NEW MEXICO HOME BUILDERS ASSOCIATION

Attention: Hearing Officer
Re: Adoption of 2017 NM Electrical Code

2017 NEC CODE CHANGE

APPLICABLE SECTION/TABLE/FIGURE NUMBER(S) 210.52(C)(3) Peninsular Countertop Spaces

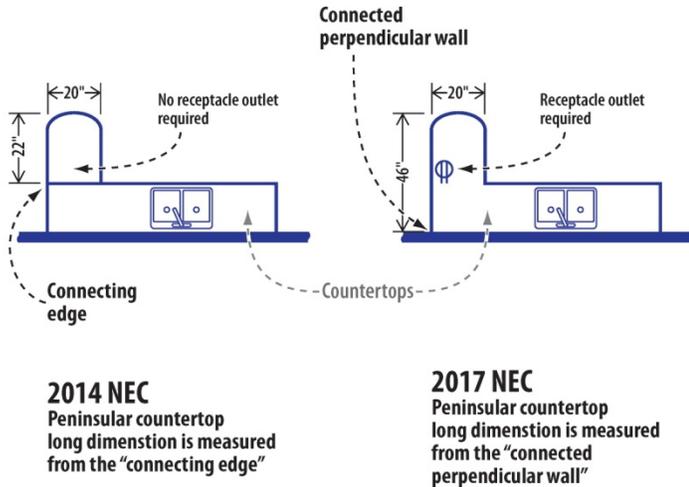
~~**(3) Peninsular Countertop Spaces.** At least one receptacle outlet shall be installed at each peninsular countertop long dimension space with a long dimension of 600 mm (24 in.) or greater and a short dimension of 300 mm (12 in.) or greater. A peninsular countertop is measured from the connected perpendicular wall.~~

This will require kitchen remodels with an eating counter on the end to have an additional outlet when none was required previously. Under other provisions, that outlet will have to be either a GFCI/ACFI combo receptacle or AFCI. There is no apparent reason for this new requirement, as folks sitting at an eating counter perpendicular to the wall generally are not operating appliances or otherwise requiring their own electrical outlet.

For kitchen remodel projects in older homes this could lead to a requirement for an entirely new electrical panel to accommodate the AFCI/GFCI combo breaker. This is an unnecessary cost increase that shows no benefit.
